**SCHEMATIC DESIGN REVIEW MEETING NO. 3 / DECEMBER 3, 2014**

2014.12.03

CHM Layout Ed. 13  
from Master 2+3  
(Levels)

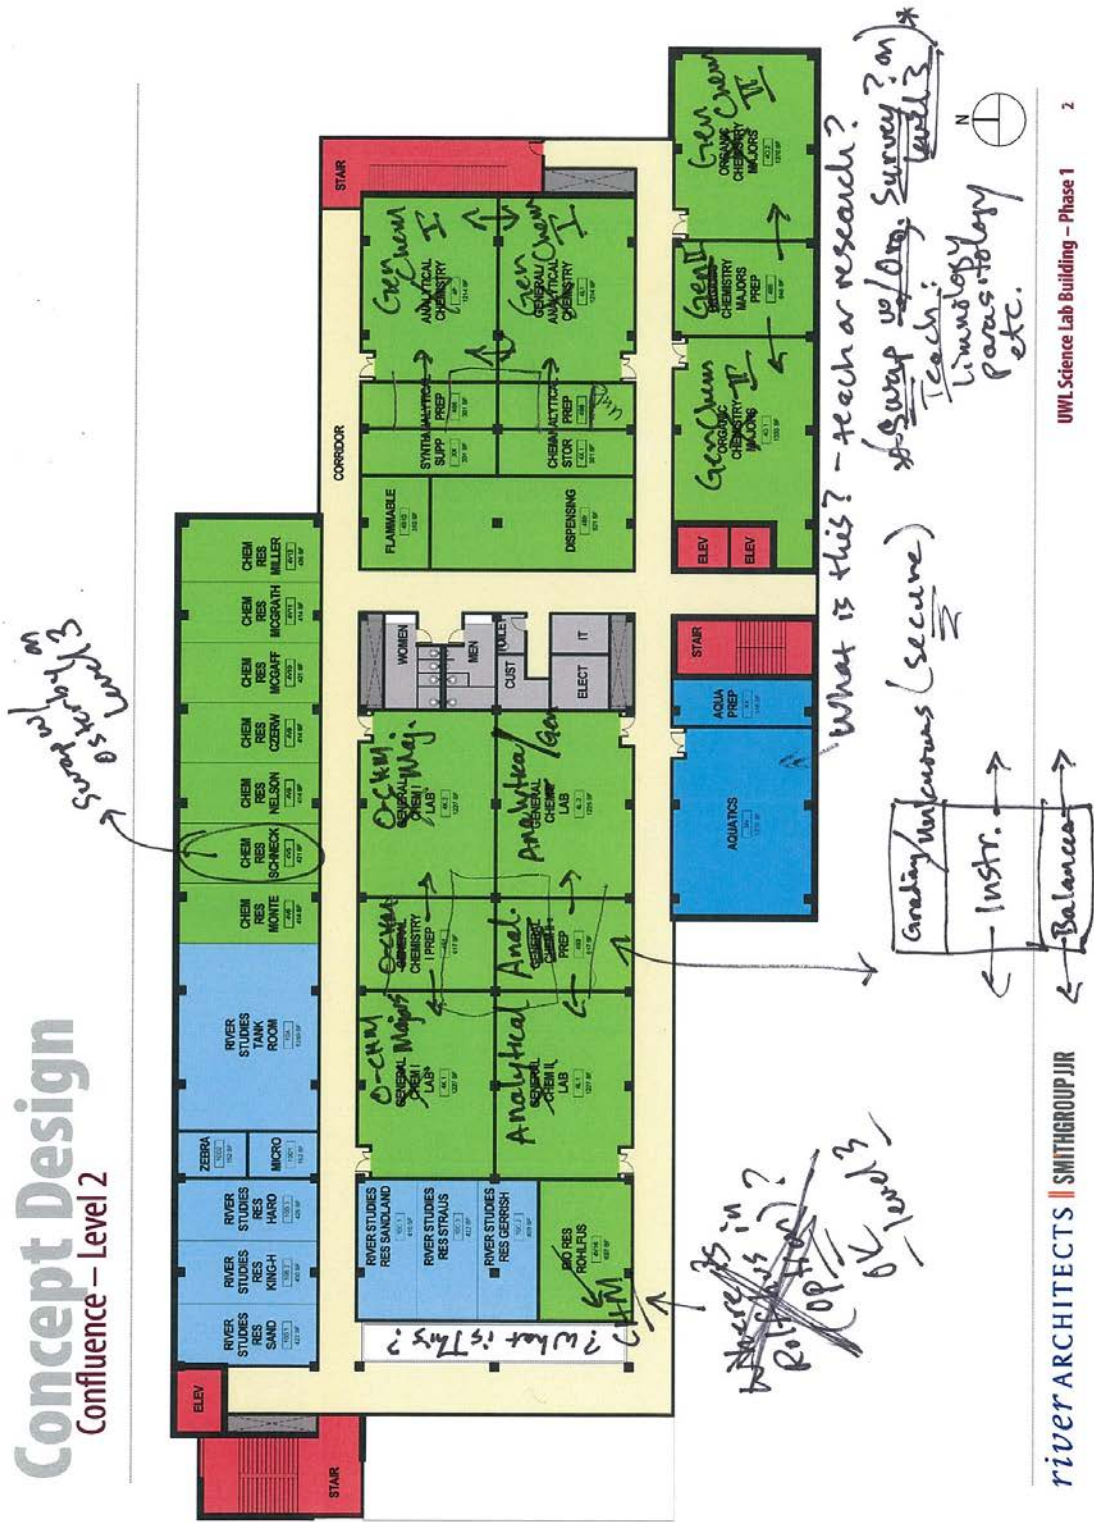
- e. Aaron Monte commented that Chemistry would prefer to move the General Chemistry and corresponding support spaces to the east block and move Analytical Chemistry to the west block. See attached sketch.

**Concept Design**  
 Confluence – Level 2 (Option) *Isolated*

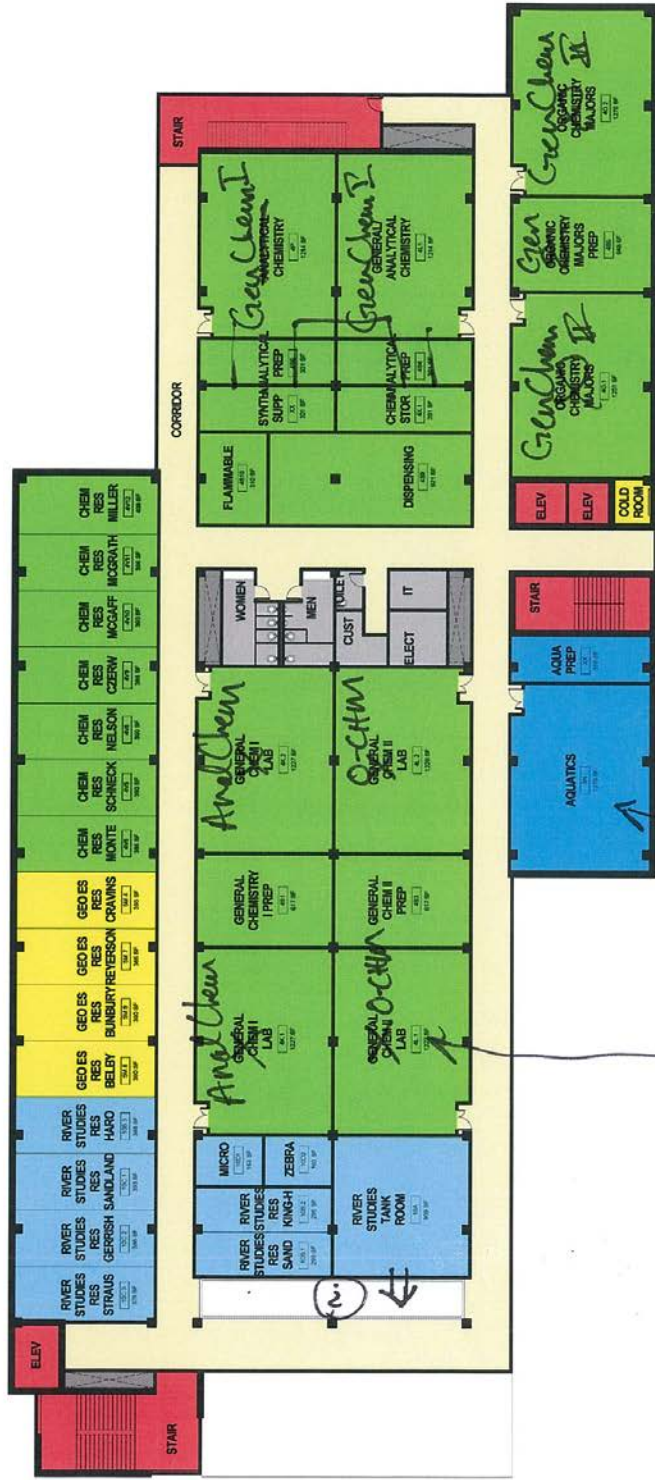
- g. Consider switching Organic Chemistry Survey Lab with the Aquatics Lab.
  - h. Mike Abler commented that the Microbiology teaching lab quantity is out of proportion compared to other departments. There appears to be a duplication with the Immuno/Viro Lab and this space will be removed.

*If this is Survey Organic then*

**Concept Design**  
 Confluence – Level 3

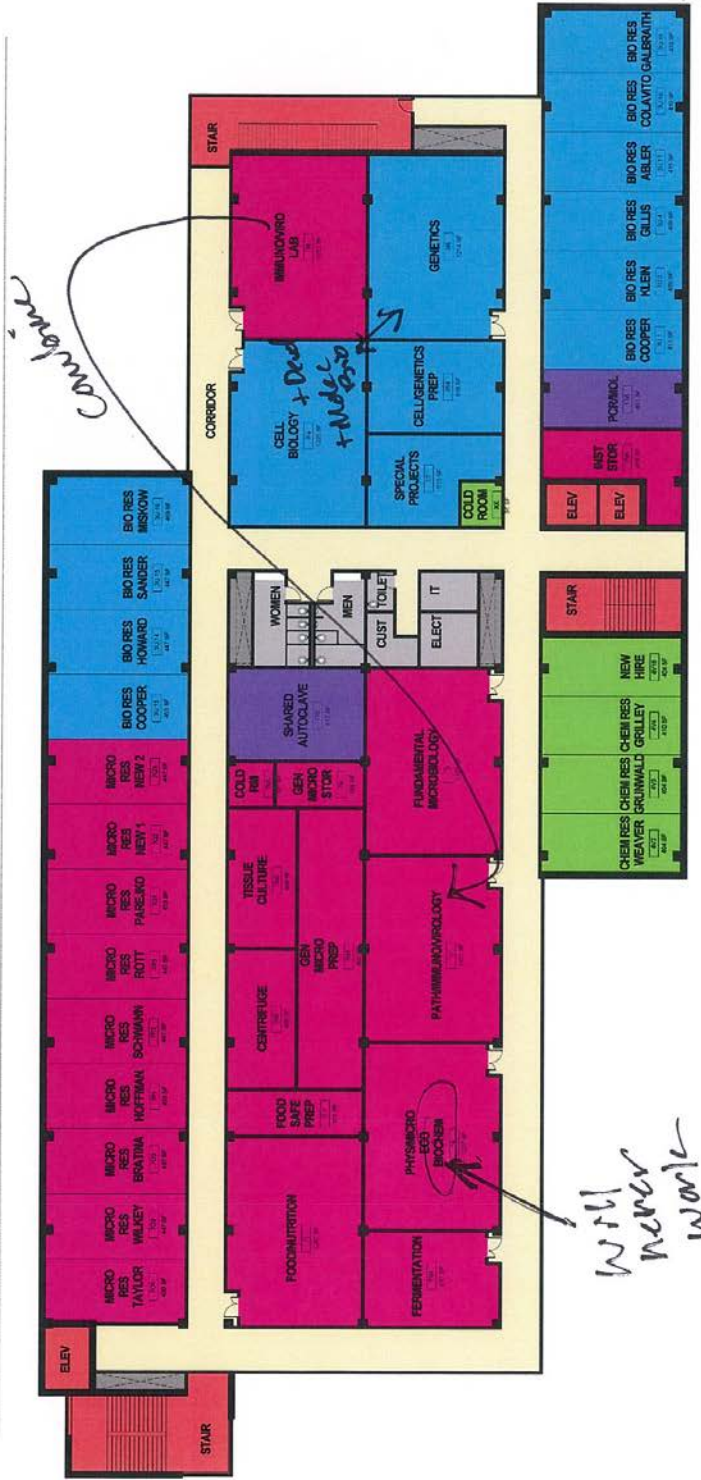
*Bioreactors (Schematics) Swap w/ Schemk on Level 2*
